Version 3

Rattle/Squeak from the Head Up Display (HUD) Area

Supersede 19-083, dated August 16, 2019, to revise the information highlighted in **yellow**.

UNDERSIDE OF HUD DISPLAY TRIM

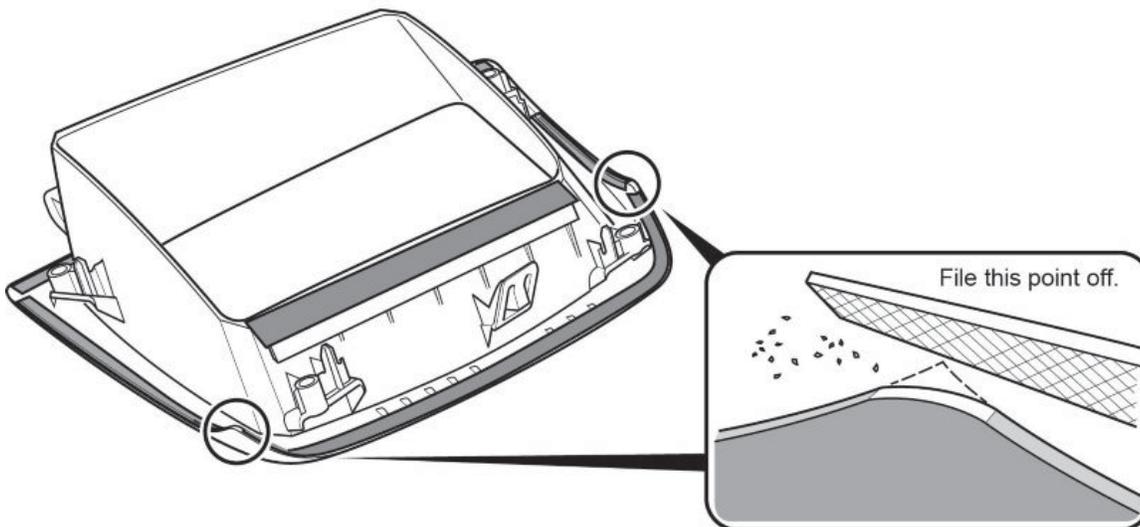
4. Apply the four cut pieces of wool felt to the areas shown.

- Cut four pieces of wool felt: 5 mm x 90 mm, 5 mm x 212 mm, 5 mm x 220 mm, 8 mm x 136 mm.

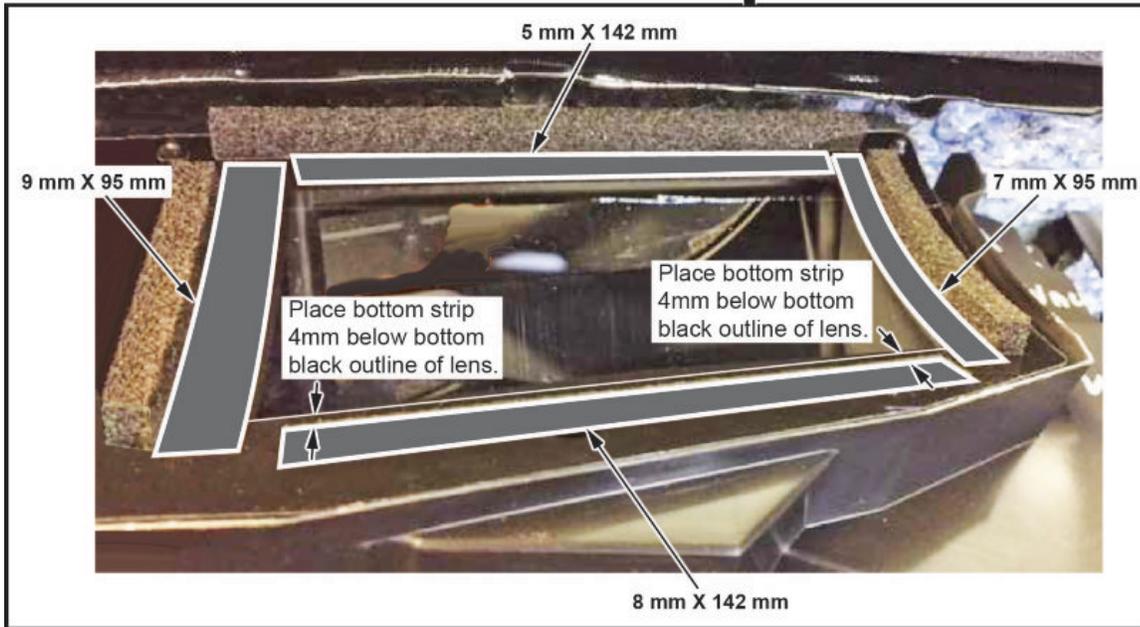
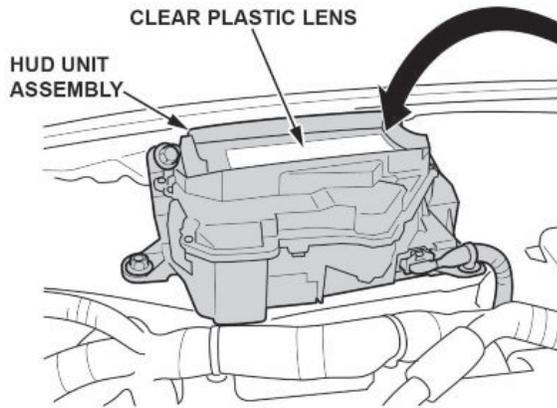
5. Lightly file the corners as shown to round them off.

7. Apply the four cut pieces of wool felt to the outside of the clear plastic lens as shown.

6. Cut four more pieces of wool felt: 5 mm x 142 mm, 7 mm x 95 mm, 8 mm x 142 mm, 9 mm x 95 mm.
